SERVICE BULLETIN

AMPEX

TRANSPORT CHANGES

BRAKES, BRAKE BAND REPLACEMENT AND TENSION ADJUSTMENTS

INSTALLATION OF GATE SPRINGS IN 475 SERIES AND SIMILAR HEAD ASSEMBLIES

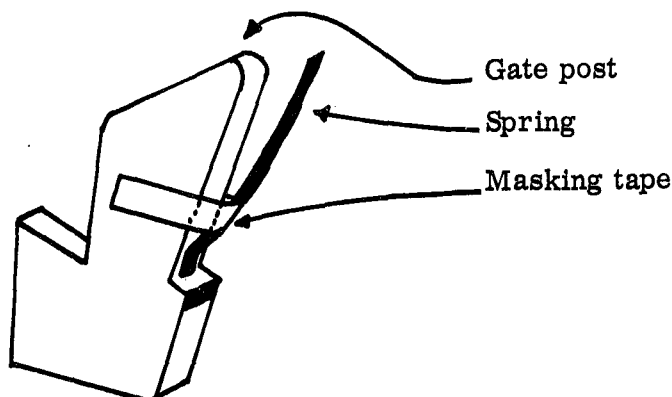
Should it be necessary to replace the 438-1 gate springs, the following method has proven to be the most practical:

1. Pull the drive pins at each end of the gate and remove the gate.
2. The springs are placed in the gate post with the crimped section in the slot as shown. They should be held in place with a small piece of masking tape. Be careful to keep the springs as straight as possible with reference to the gate post.
3. Push the gate assembly into place, in open position and insert the springs in the stop post slots during the process.
4. Insert the drive pins in the gate ends, leaving about $1/16$ " of the drive pins extending. Remove the masking tape.

MODEL 350, 351 AND 3200 SERIES

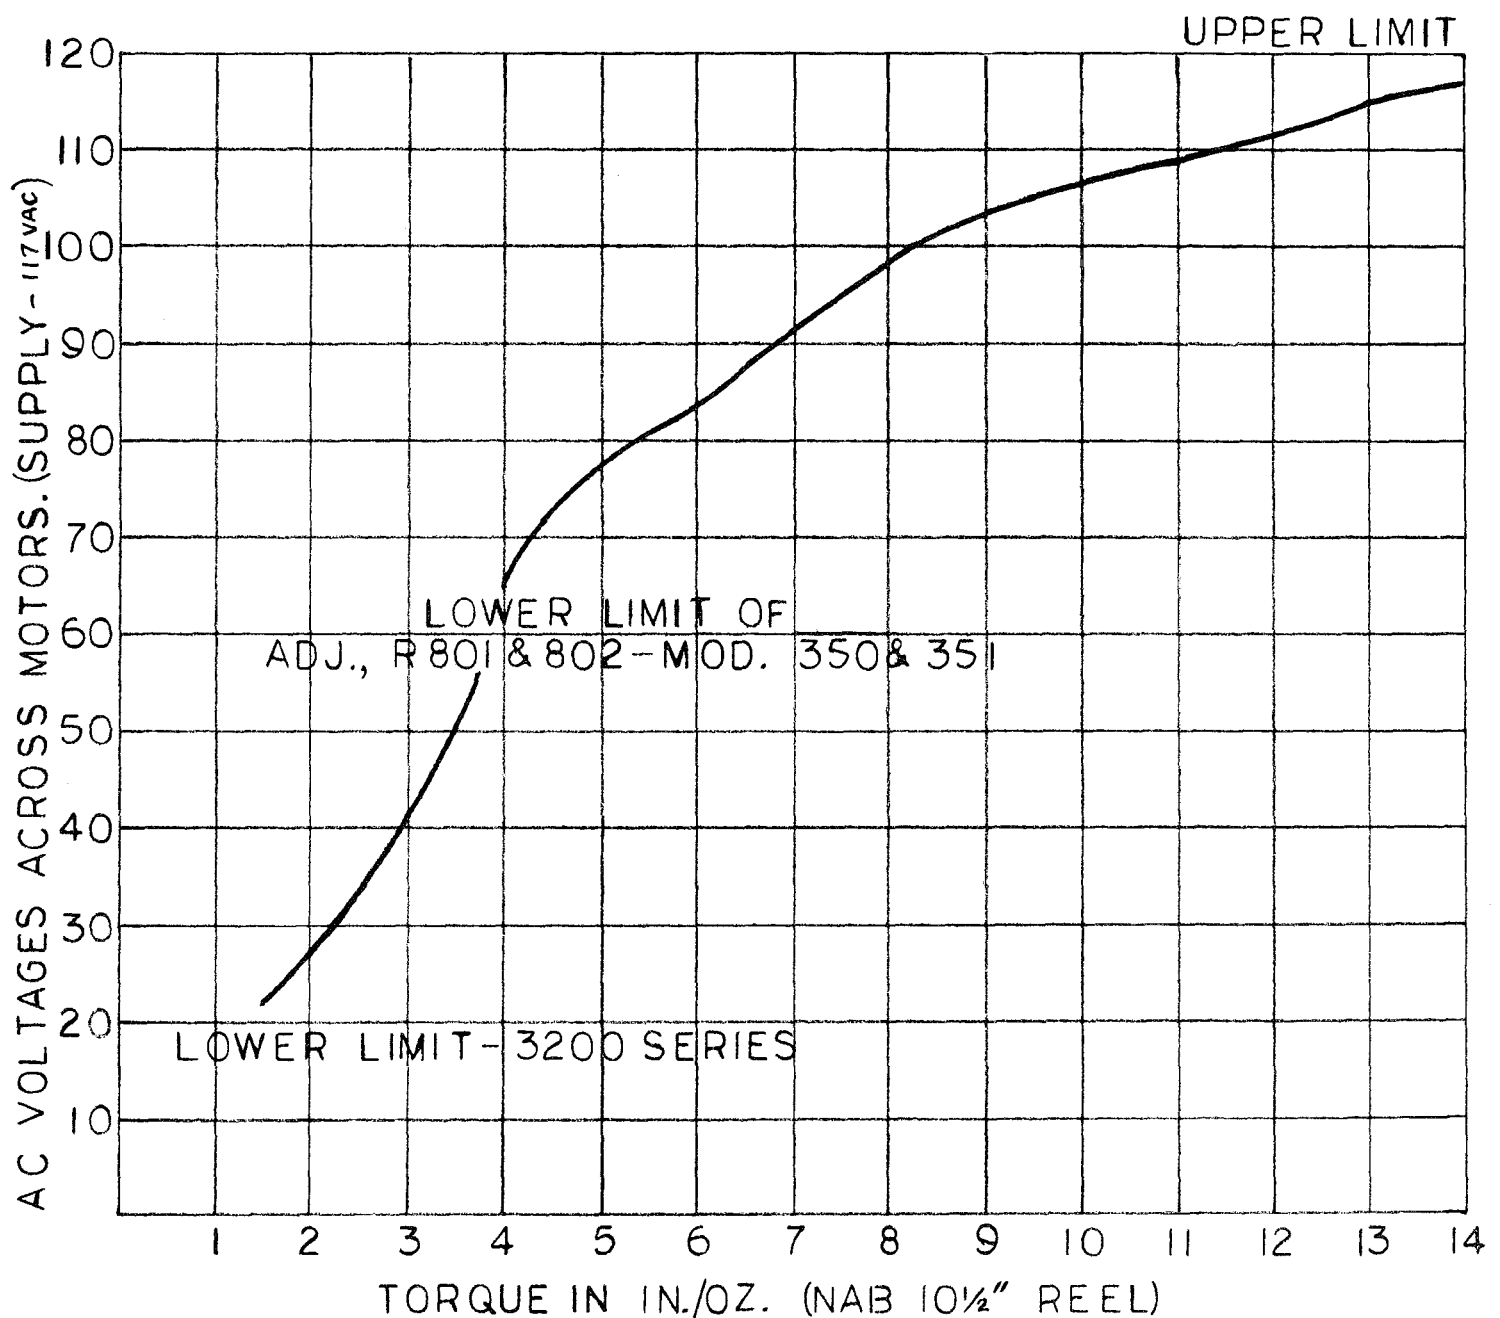
To furnish a practical alternate method of measuring and correcting torque adjustments on takeup and supply motors, substituting a voltmeter for a scale. The following curve indicates within $\pm 5\%$ the voltages measured across the motor windings for a given amount of torque.

MODIFIED A.C. CONTROL CIRCUIT

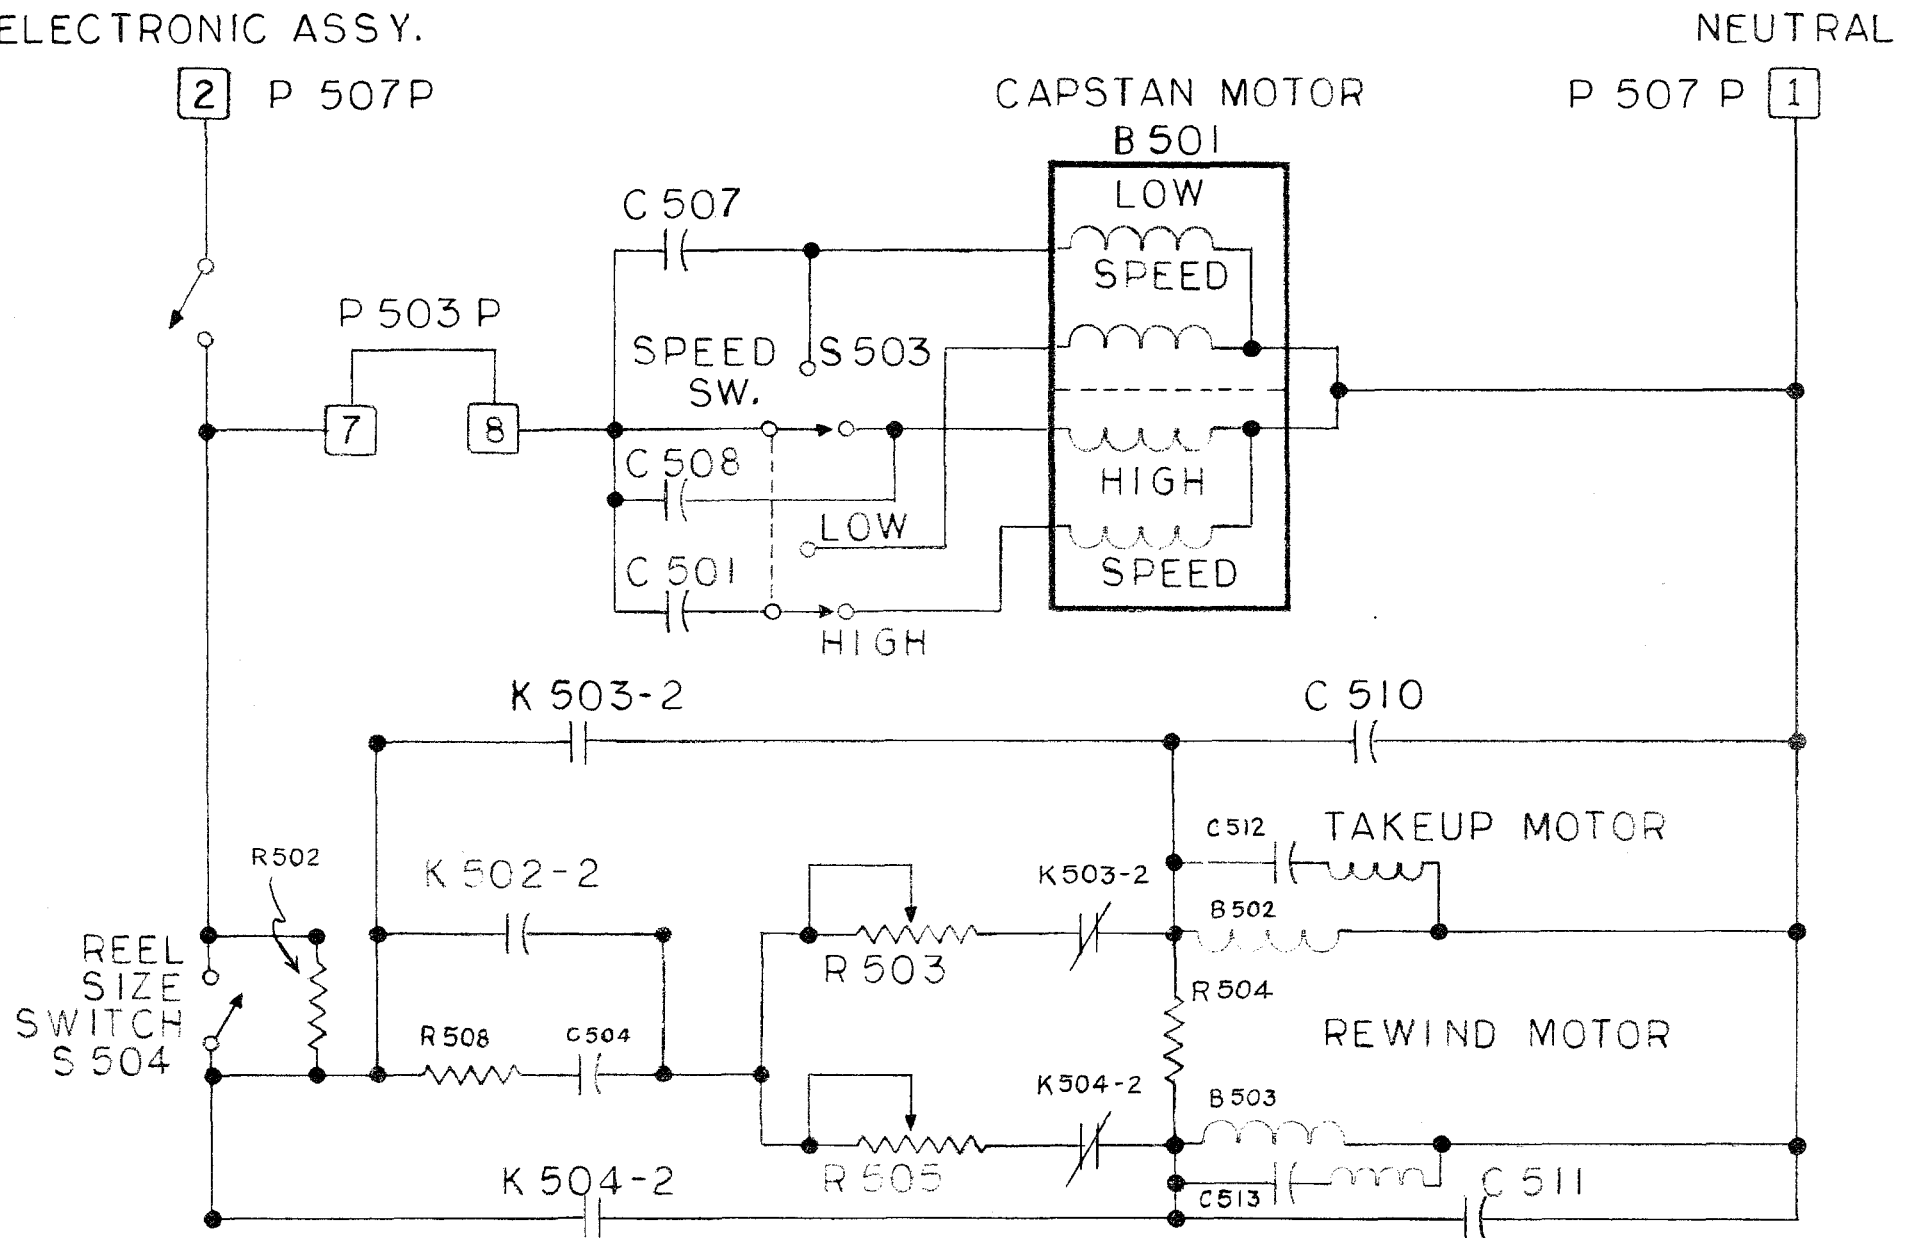
Effective August 1, 1959, Model 351 recorders incorporate certain changes in circuitry of the control box to improve fast mode tape handling characteristics in small reel position. These transports also include an improved brake assembly which provides better braking action in all modes of operation. Transports with these changes are identified as Ampex catalog number 30970. The new control box is catalog number 5703-03. The circuit change can be made in any existing 350 or 351 transport, catalog number 5700, by rewiring the 5703 control box, as follows:

A simplified schematic of rewired control box is shown in figure 1.

1. Remove control box from transport and take off screen.
2. Remove the gray jumper wire which runs between R502 and R503.
3. Disconnect the blue wire from the other end of R502 and pull out of hole in panel. Remove the sleeving for future use. Cut and tape the end of this wire.

11. Connect pin 8 of J501S to one end of R502 and pin 9 of J501S to opposite end of R502. Use high temperature insulating sleeving, where wires go thru hole in panel and run wires directly thru the center of the box. They may be tied or taped together for neatness. Do not solder pins 8 and 9.
12. Connect a wire from pin 17 of J501S to the terminal of the selenium rectifier from which the two purple leads were removed.
13. Run a wire from pin 17 of J501S to pin 9 of J501S. Pins 8 and 9 should now be soldered.
14. Replace end panel and remount box on transport. Dress wires from R502 neatly thru center of box and against transport plate. Replace screen.

FIG. 1

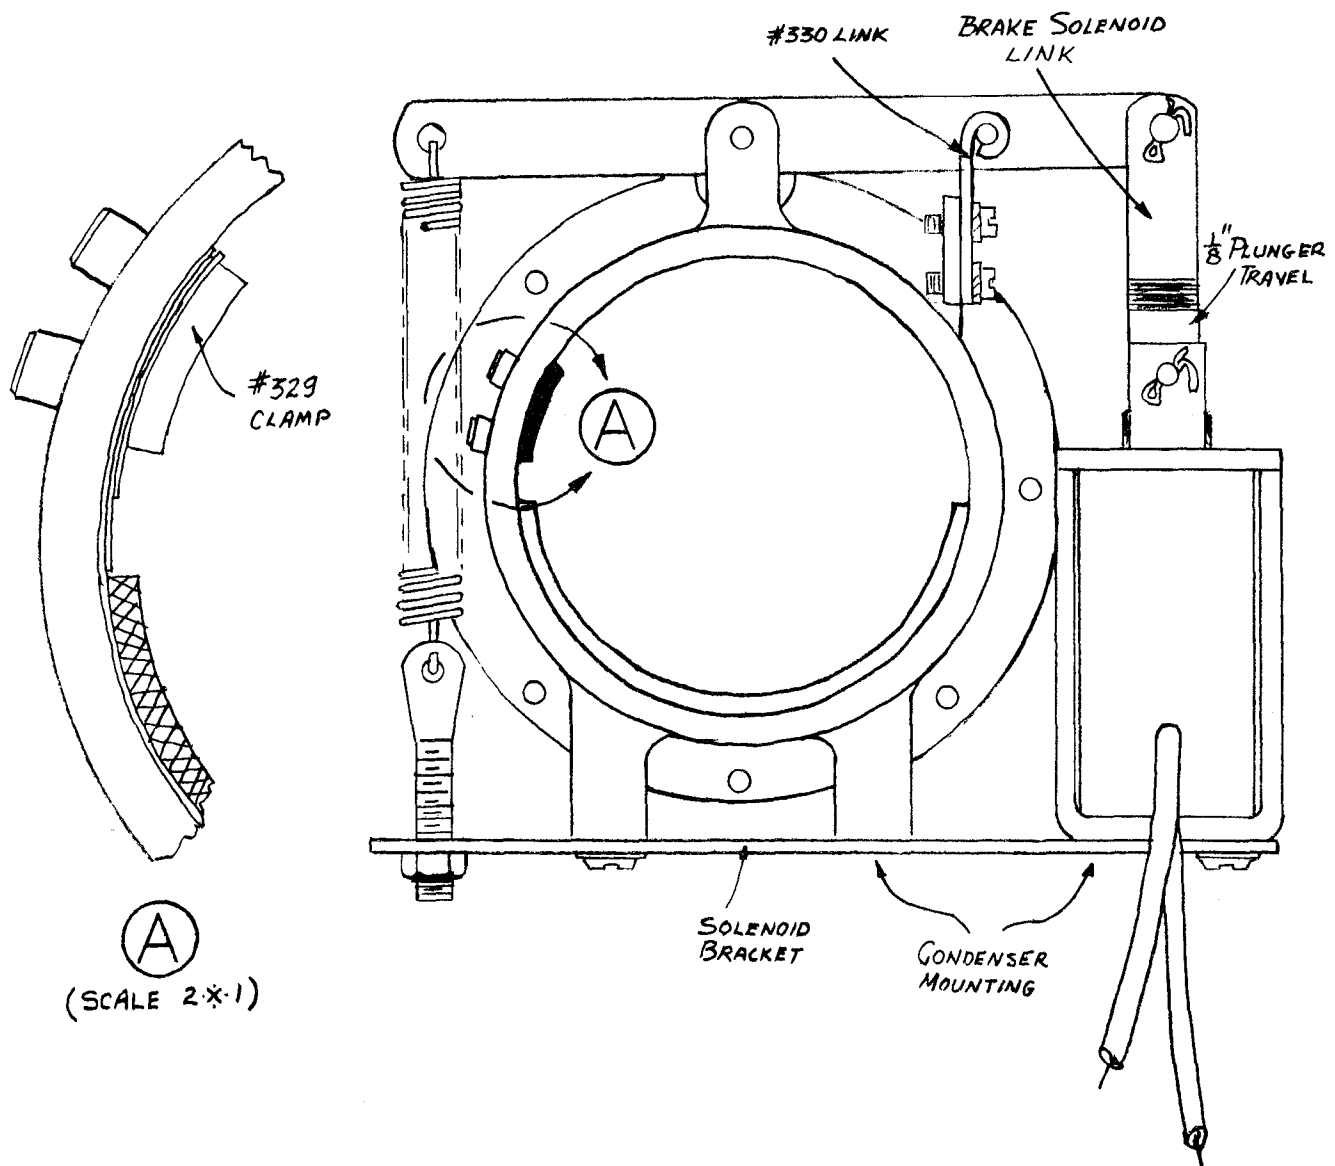
Two different designs of Brake Assemblies have been used on the Model 300 and Model 350 Series Recorders. The earlier design, which was discontinued on production models of the 300 Series and 3200 Series during 1956 and the 350 Series on August 1, 1959, is shown in Figure I.

This design used graphited felt brake bands and one brake tension spring which is adjustable to maintain proper brake tension settings.

FIG. 2

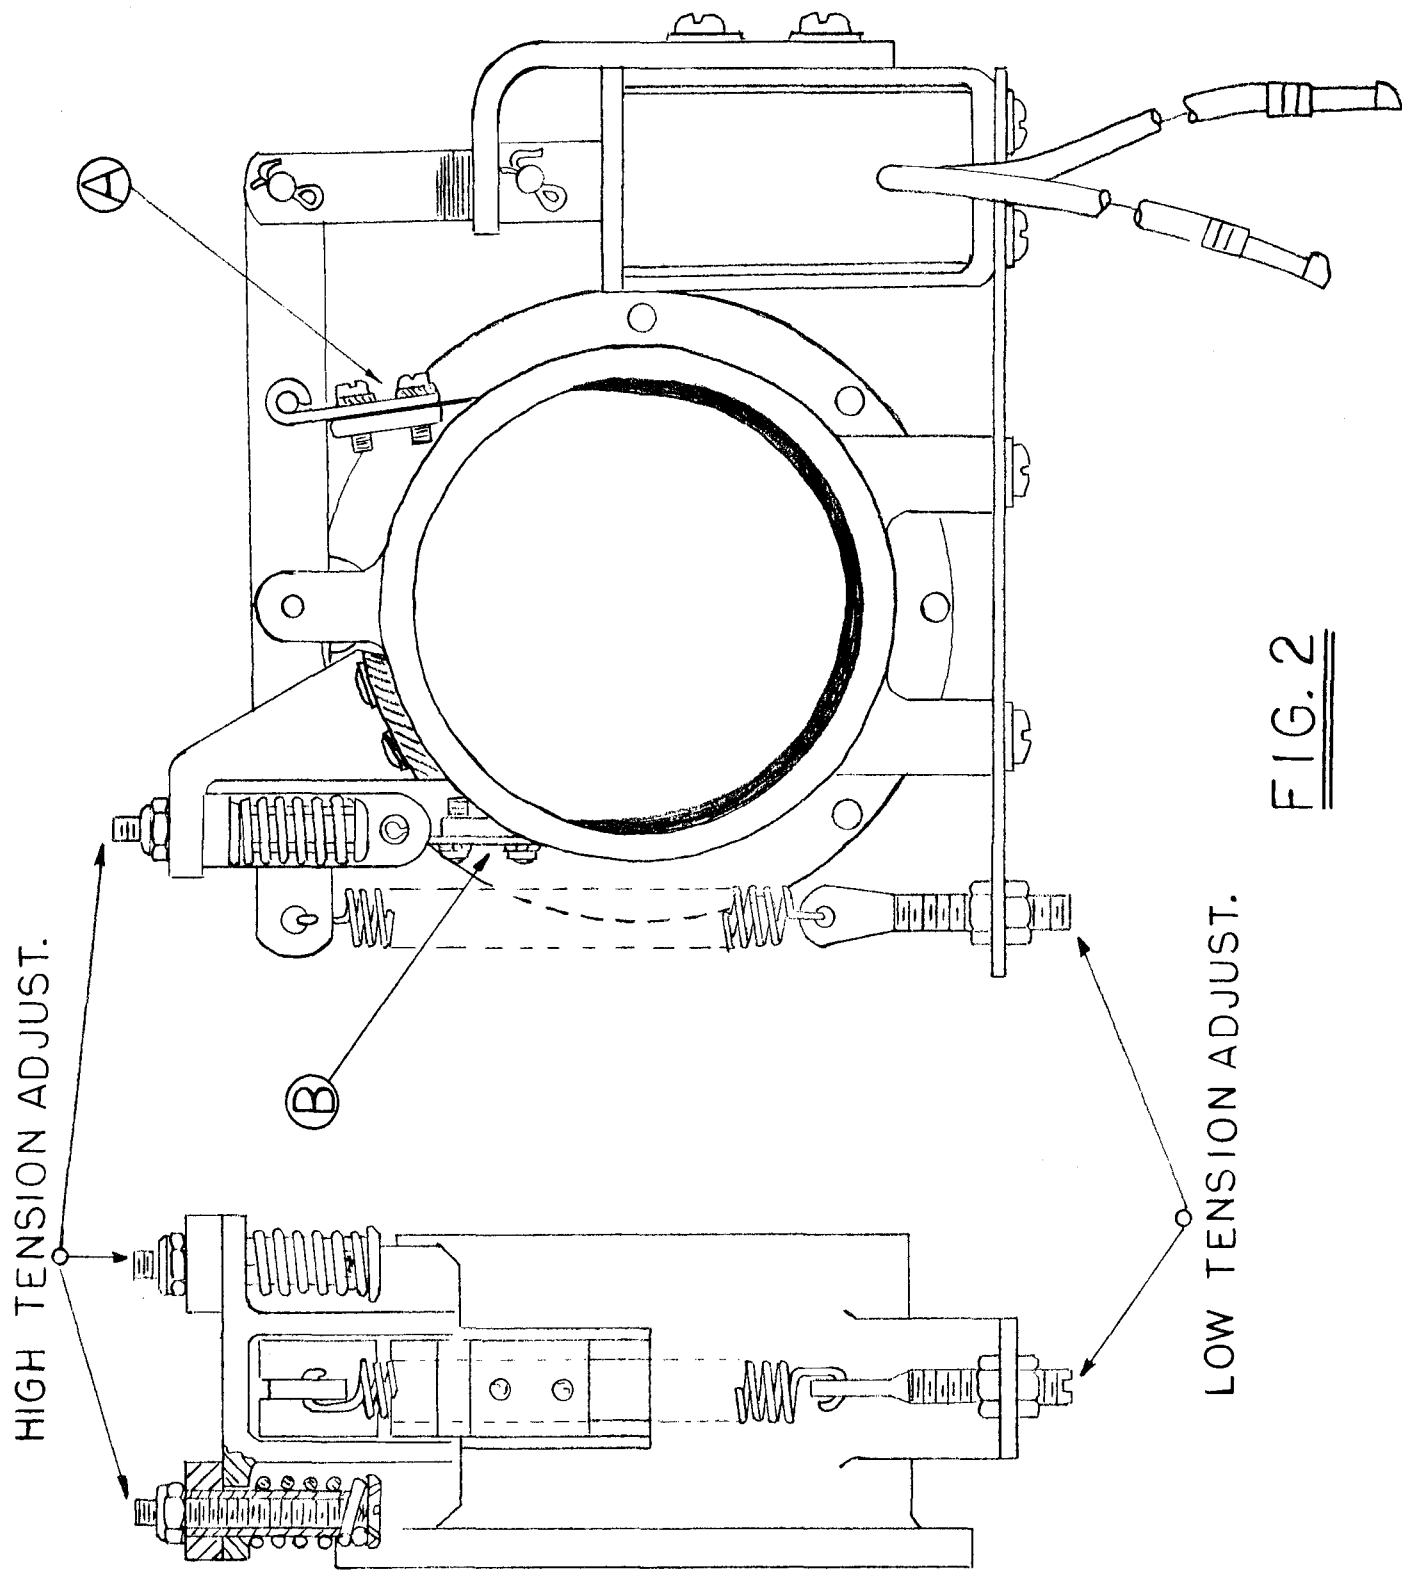
The new brake assembly shown in Figure II is currently used on production Models 300, duplicator and 351 series recorders.

This design uses a Raybestos brake band with two adjustment points to maintain proper brake tension settings. To replace the older brake assemblies with the newer version simply order by Ampex catalog number below:
